# Product Change Notification

<b>Date Issued :</b>	August 10, 2023	<b>PCN Number :</b>	514154
<b>Reason for Change :</b>	Change Supplier		
<b>Description of Change :</b>	Molex's Resin supplier inform Molex that current plant will not produce Valox PBT in the future. To avoid from line down situations either for Molex or for our customers. Molex accepts resin supplier's proposal to qualify their China Nan Sha source material.		
<b>Assessment of Change :</b>	Dimension analysis		
<b>Planned Implementation Date :</b>	February 18, 2024		
<b>Sample Availability Date:</b>	November 20, 2023		
<b>Internal Molex Qualification Date :</b>	November 15, 2023		
<b>Last date to request Samples by Customer :</b>	November 30, 2023		
<b>Traceability Code Markings / Date :</b>	Date code

MODULAR JACKS

## ■ Photo of affected product

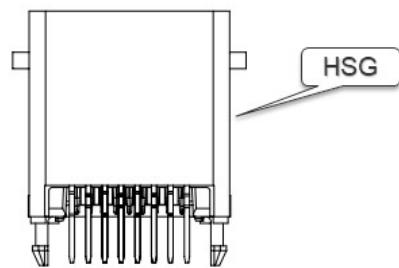
- Molex's Resin supplier inform Molex that current plant will not produce Valox PBT in the future. To avoid from line down situations either for Molex or for our customers. Molex accepts resin supplier's proposal to qualify their China Nan Sha source material.
  - Before : Shang Hai source material
  - After: Add China Nan Sha source material (Same vendor, same material grade, only manufacture location change)
- **Product Impact**
  - Material grade does not change, "no impact to fit, form, function".
- **Part Number Impact** - see attached impacted parts list
- **Planned Implementation date.**
  - 18th Feb 2024
